Final draft **EN 300 403-1** V1.2.2 (1998-01)

**Integrated Services Digital Network (ISDN);  
Digital Subscriber Signalling System No. one (DSS1) protocol;  
Signalling network layer for circuit-mode basic call control;  
Part 1: Protocol specification**

[ITU-T Recommendation Q.931 (1993), modified]

The text of ITU-T Recommendation Q.931 (1993) was approved by ETSI as an EN with agreed modifications as given below.

Figure H.5 (sheet 2 of 5): Message reassembler SDL

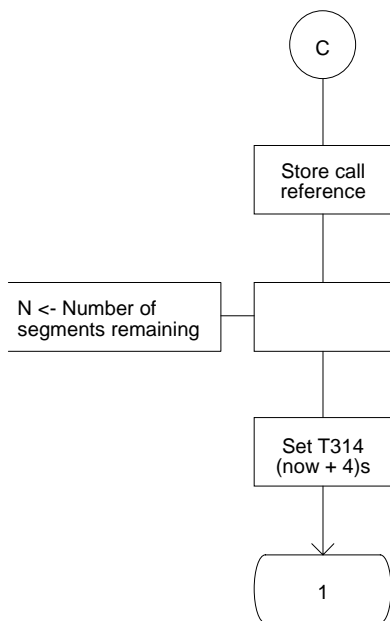
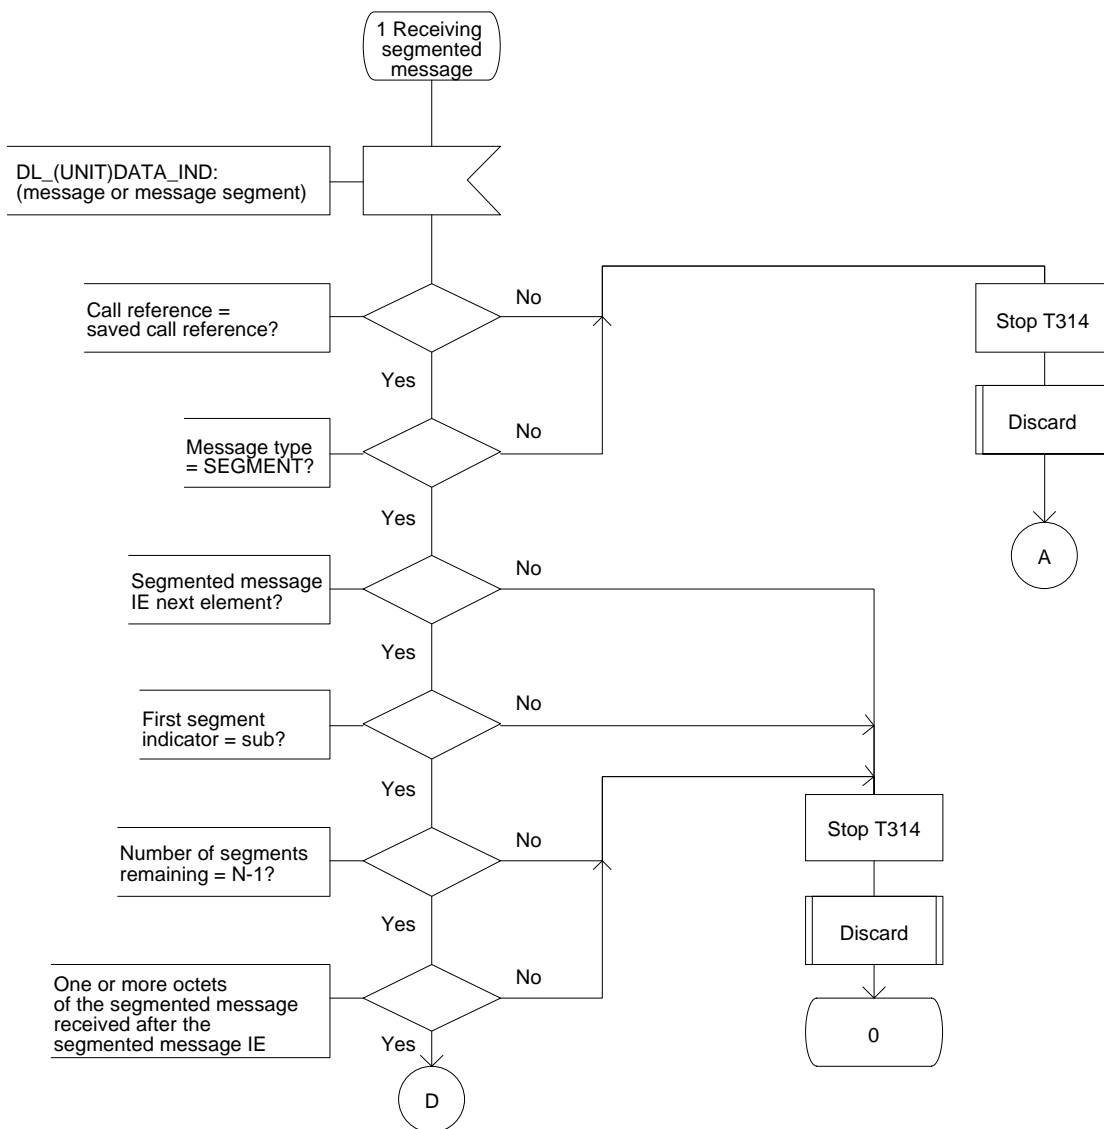
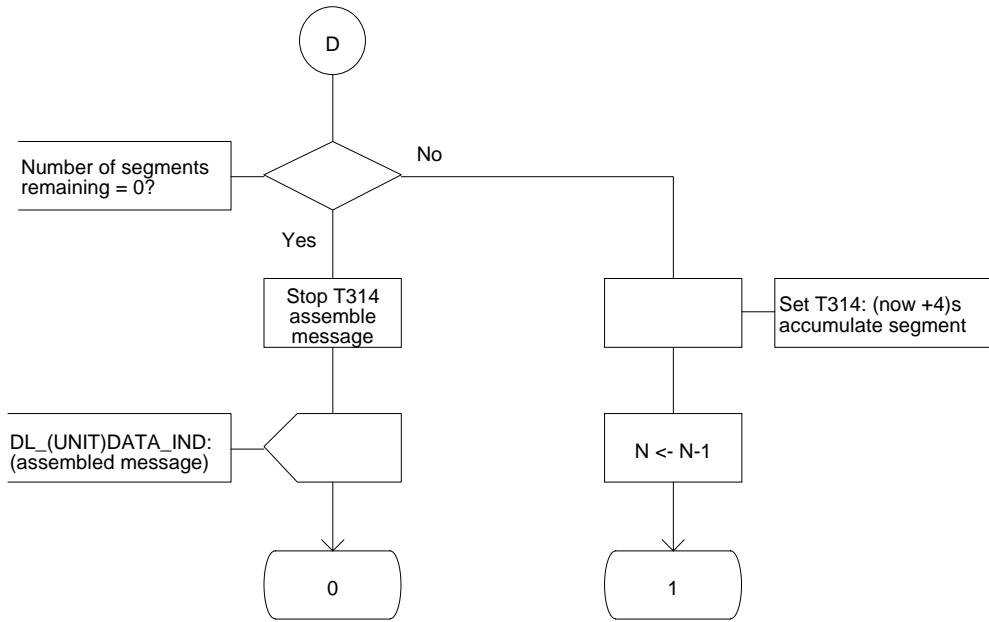
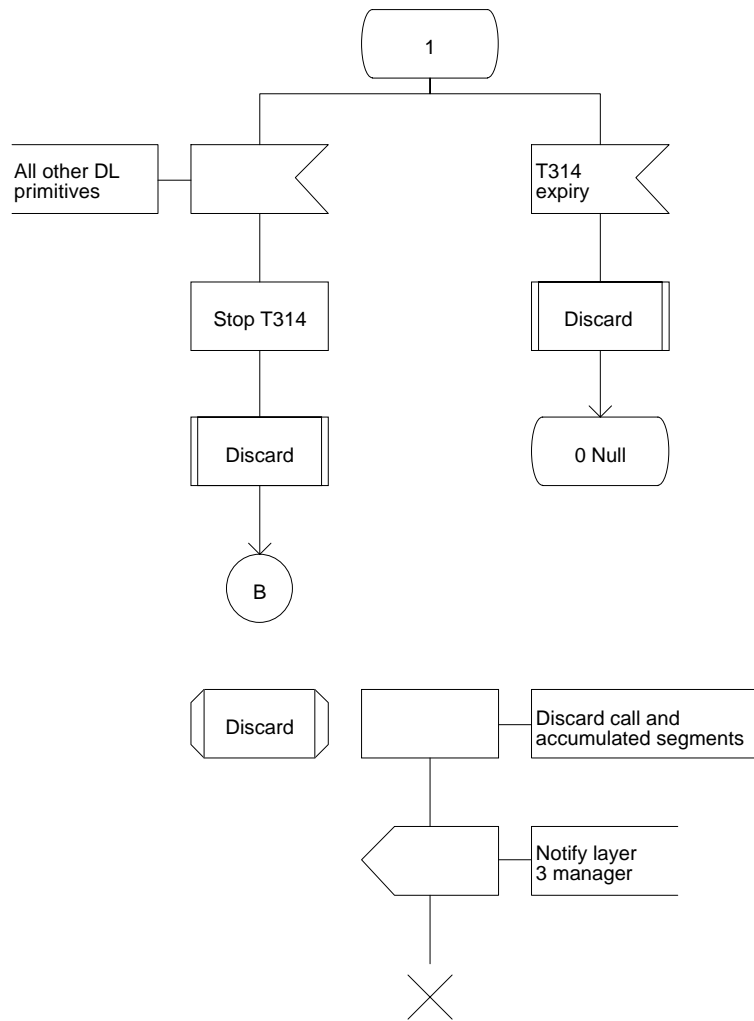
- 21) Some additional error handling procedures have been specified for the message segmentation procedure in annex H.
- 22) The requirement to compare Low layer compatibility information element in the CONNECT message to the selected bearer capability has been added in the procedures for low layer compatibility negotiation between users.

l) A receiving entity, on receiving a message with a different call reference while in the Receiving Segmented Message state, shall discard all segments of the segmented message so far received, and enter the Null state. The receiving entity shall process the message received with the new call reference.

NOTE 6: Subsequent segments relating to the same message are discarded according to rule f).
